RE: Marriott Courtyard, Portland

STORMWATER MANAGEMENT PLAN

October 22, 2012
Revised: January 2, 2013

Attachment T.1
re Public + staff
comments on
Site Plan

POST-DEVELOPMENT
DRAINAGE PLAN

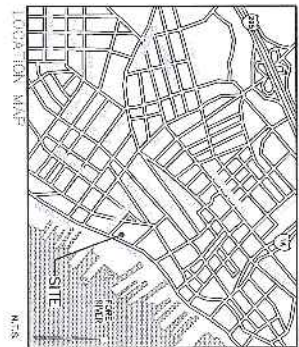
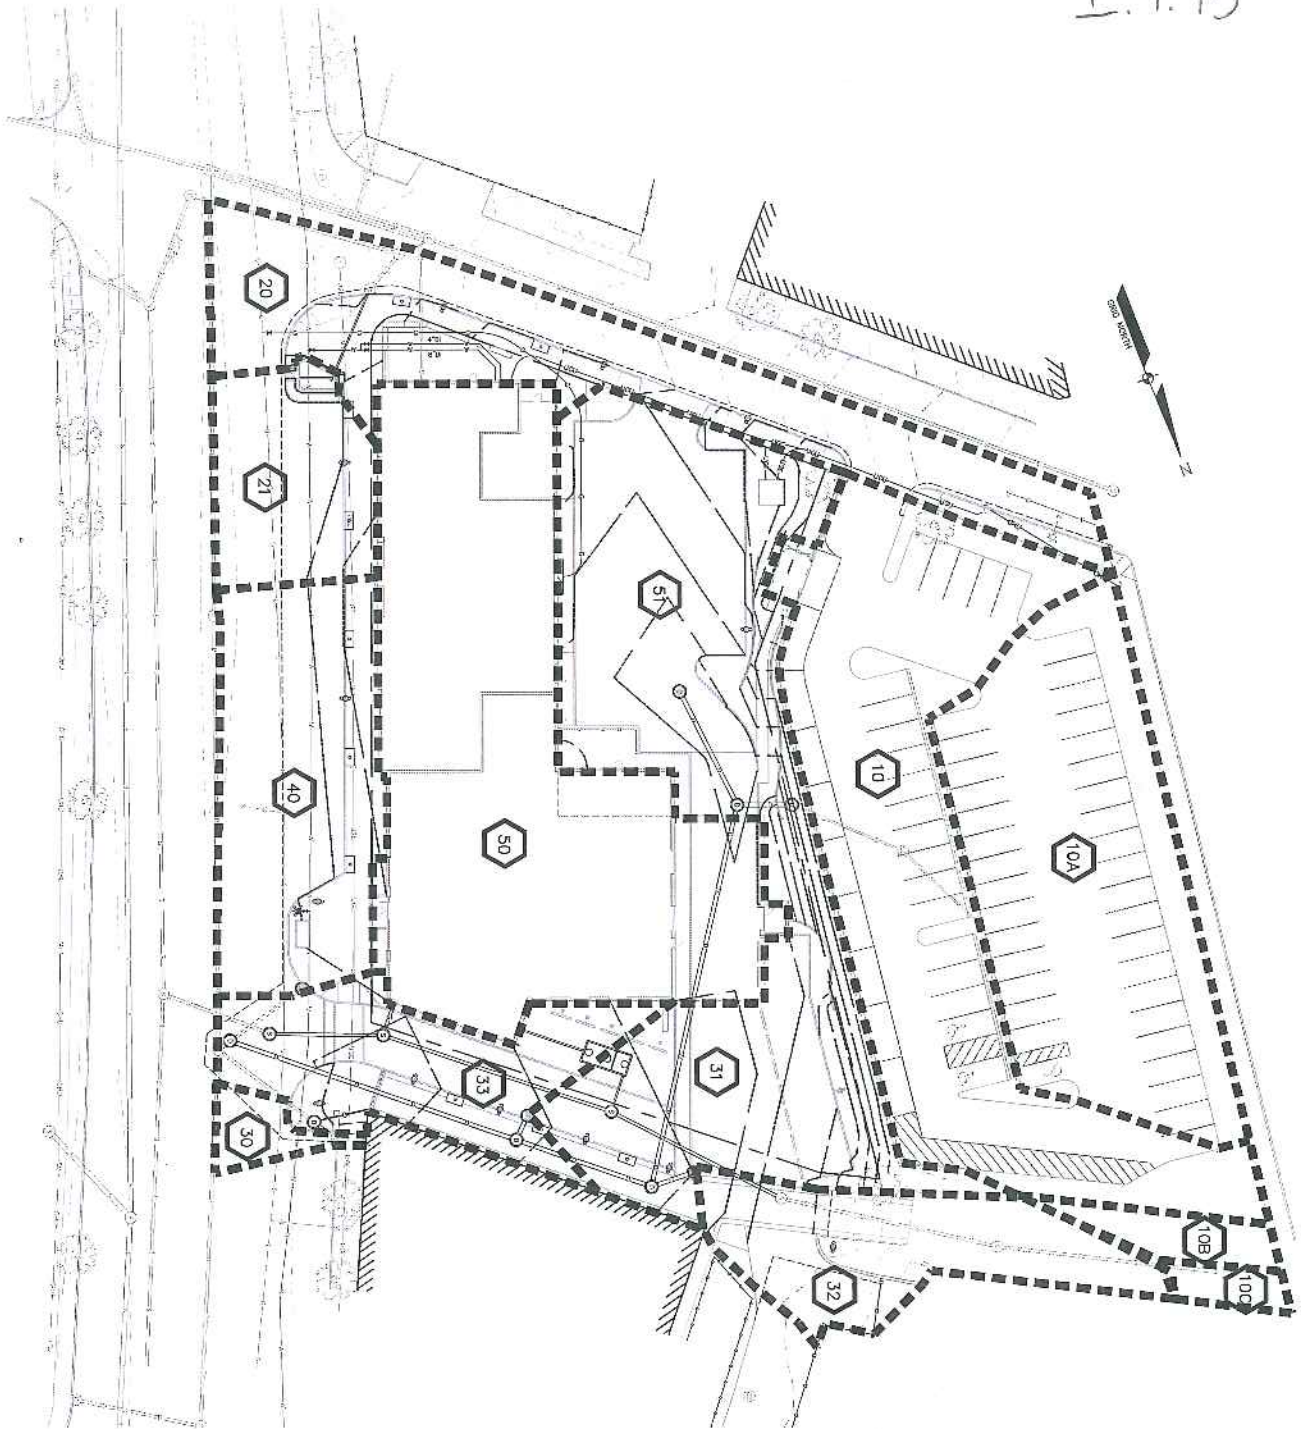
1. The Applicant has identified a "green area stormwater treatment" system Within a bump-out on Commercial Street to provide water quality treatment for approximately 6,810 sq; ft of sidewalk,, roadway, and on-street parking area. This system would provide treatment for an area in excess of the proposed new impervious area resulting from the project (2,513 sq ft). Pending review of the design details associated with this system, the proposal provides an acceptable means of meeting the City of Portland's water quality treatment requirements. We understand that additional information and plan revisions are forthcoming, and we anticipate reviewing engineering calculations for the treatment system, specifically the ability to provide water quality treatment for the 1", 24-hour storm event. In addition, we will review design details and modifications to the Inspection and Maintenance Plan. The system is proposed within the municipal Right-of-Way, so the Applicant will need to execute an agreement with the City of Portland specific to inspection and maintenance responsibilities.

A green area stormwater treatment area is now being proposed within the bump out at the Commercial Street and Maple Street intersection. Please see the attached Post-Development Drainage Plan showing the impervious area (Subcatchment 21) to be treated. There will be a total of 3,950 sq.ft. of impervious area directed to the stormwater planter. The planter cross-section will be revised as per the attached plan view and details. The revised planter will have 18 inches of soil media and a 6 inch perforated PVC underdrain, within 24 inches of crushed stone. This will allow the volume of runoff created by the 1", 24-hour storm event to be treated. Please see the attached HydroCAD printout that demonstrates the planter's capacity.

Inspection and maintenance of the stormwater quality treatment feature has been added to the Inspection and Maintenance portion of the Stormwater Pollution Prevention Plan

The Historic Preservation Board comments dated 11/09/12

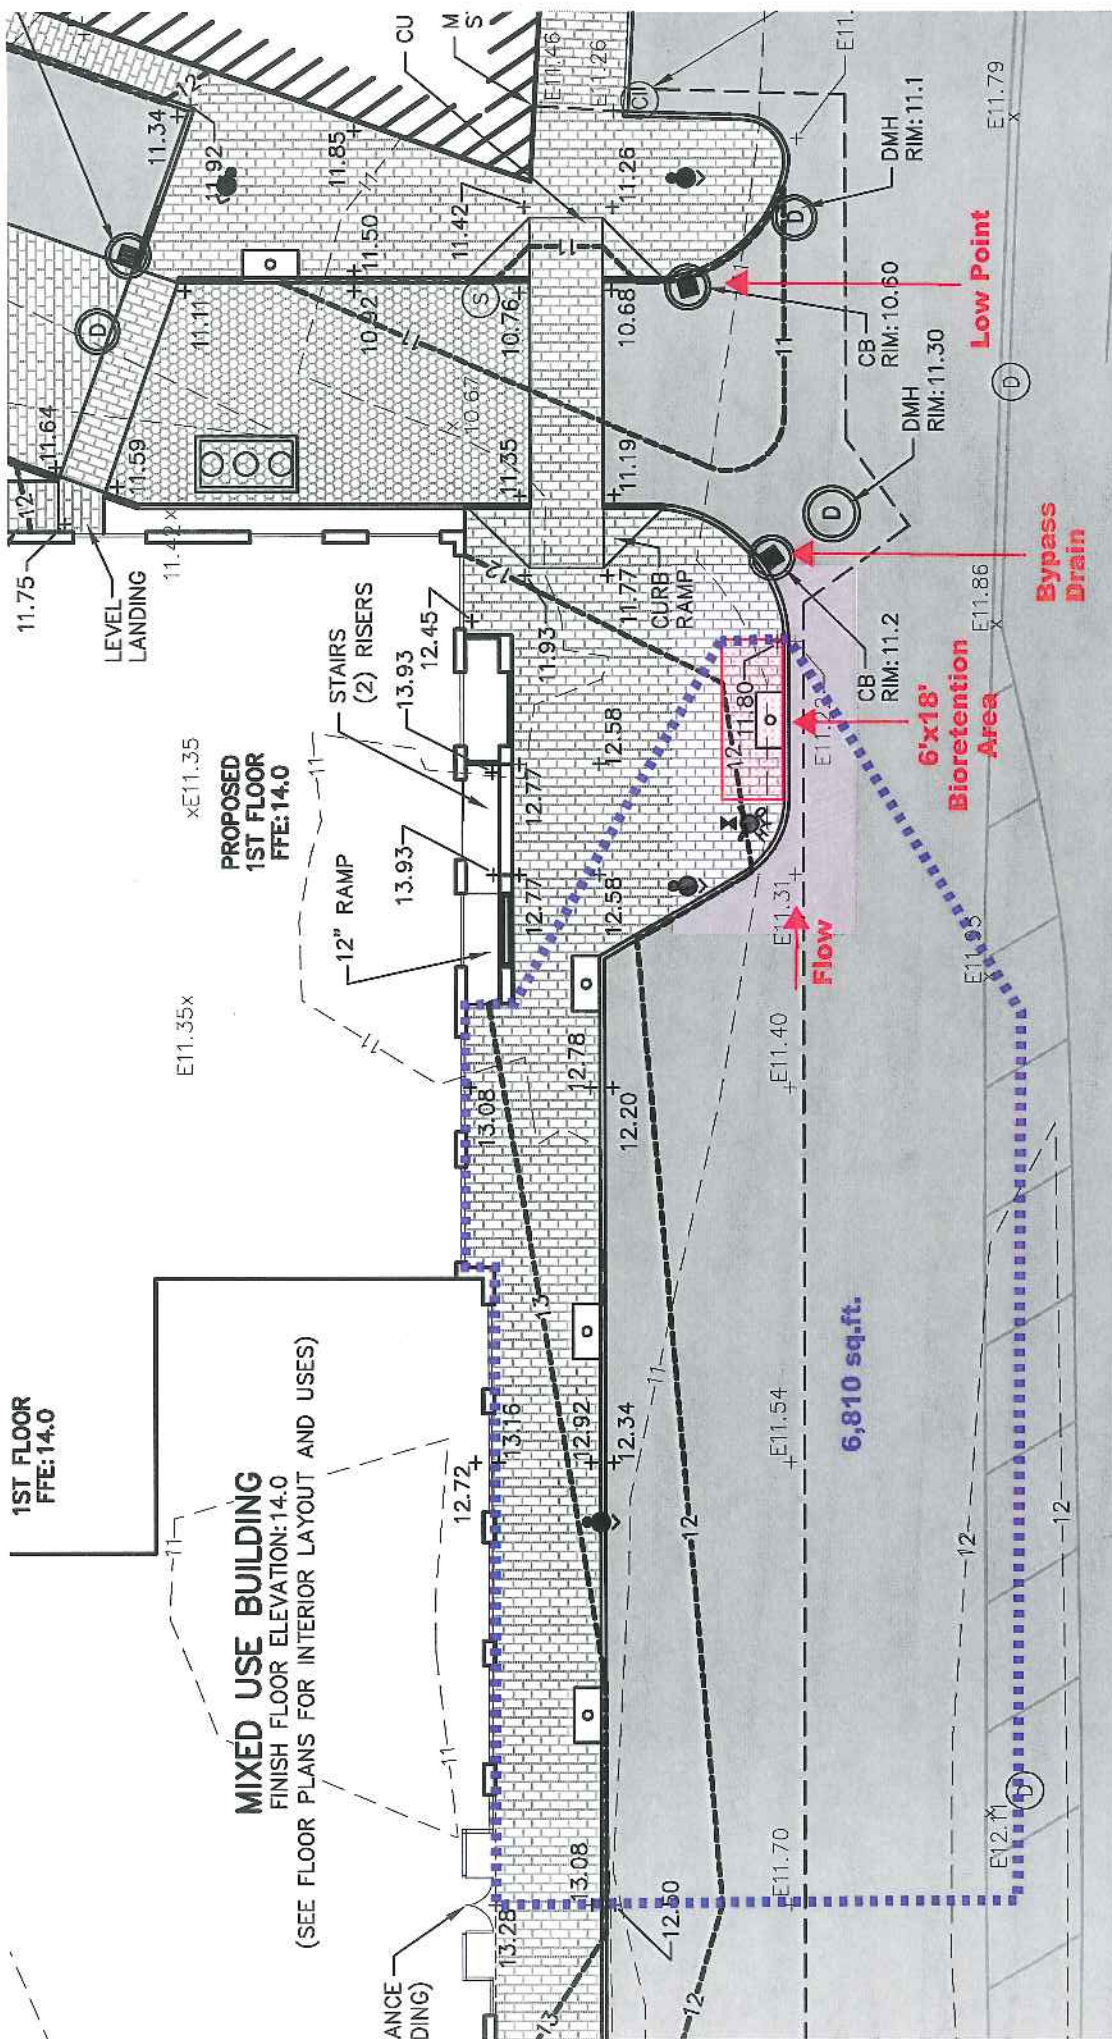
The Historic Preservation Board held a preliminary review of the proposed hotel development at 321 Commercial Street on November 7th. Recognizing that the plans, elevations and perspective views were still quite preliminary, Historic Preservation Board members did express a threshold concern about the plan and massing of the proposed building as it relates to the geometry of the subject parcel and the abutting street and alleyway. They also raised a number of questions and concerns about the building design. Regarding Foundry Lane, Board members noted that its treatment at the top of the block, done as part of an earlier project, was very successful in that it preserved the memory of the historic alleyway and created an attractive pedestrian corridor. They felt it was important that this treatment continue on the lower portion of Foundry Lane to the extent possible.

Please see the attached submission to the Historic Preservation Board.

01-02-13 Response: We have revised the layout and design of Foundry Lane. The building was reconfigured at the corner of Foundry Lane and Commercial Street to match the angle of the Baxter Building at Foundry Lane. Also, Foundry Lane was revised to continue the width and consistent detailing of the walkway from York Street to Commercial Street. With that said, revisions resulted in a reduction of proposed parking spaces, a reduction in the driveway width, the bike rack was relocated, and the site lighting is now proposed to strictly match the adjacent existing lighting of the upper parking lot and Foundry Lane.

Response to Traffic Comments

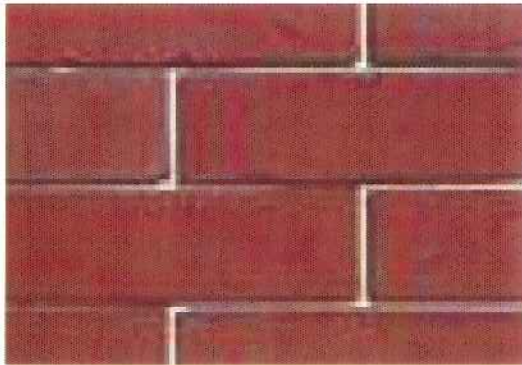
- ITE Parking Generation Manual, 4th Edition: We have reviewed data available for Land Use Code 310, for Hotels, from the Manual. On page 73 of this Manual, Hotels in urban sites are specifically discussed. Parking demand data for 5 urban sites were reviewed and indicated a weekday average peak parking demand of 0.64 vehicles per occupied room. Based on this rate the proposed 131 room hotel would require 84 parking spaces. In our original parking study for the site we referenced the 0.65 rate from Hampton Worldwide data, noted in Item 1 above. Use of the ITE rate of 0.64 would result in 2 less spaces being provided.

The two methodologies result in nearly identical parking requirements (86 spaces, compared to 84 spaces), however both are substantially higher than the City ordinance, 14-332(c), which would require only 33 spaces based on a rate of 0.25 spaces per room.

Based on this updated parking demand analysis, we recommend utilizing the 86 hotel spaces determined in our original parking demand analysis submission.
